Subject: Dresden Nuclear Power Station Unit 2
 SEP Topic VI-7.C.1 Item No. 4.21.5
 Isolation of Class IE Sources
 from Non-Class IE Loads
NRC Docket No. 50-237

This letter addresses the concerns of SEP Topic VI-7.C.1 Integrated Assessment Summary Item No. 4.21.5 entitled "Isolation of Class IE Sources from Non-Class IE Loads".

CURRENT IN AMPERES AT 12.5 VDC

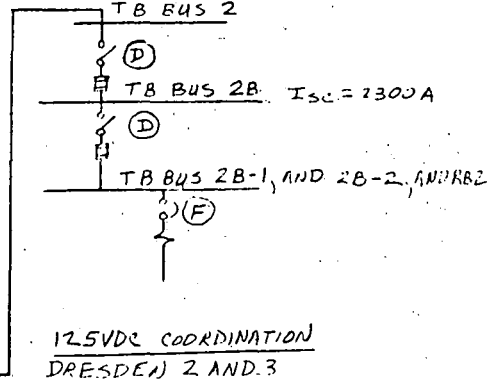
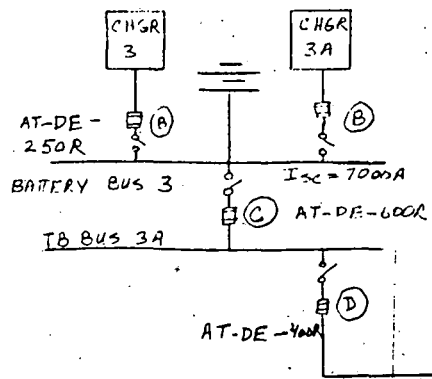
In order to ensure isolation of the DC source to Bus 27 from the essential 125VDC system, the branch breaker feeding Bus 27 must be coordinated with the main fusible switch feeding Essential 125VDC Bus 2B. Attached is a coordination study showing that coordination does exist for all levels of fault current on the branch circuit to Bus 27.
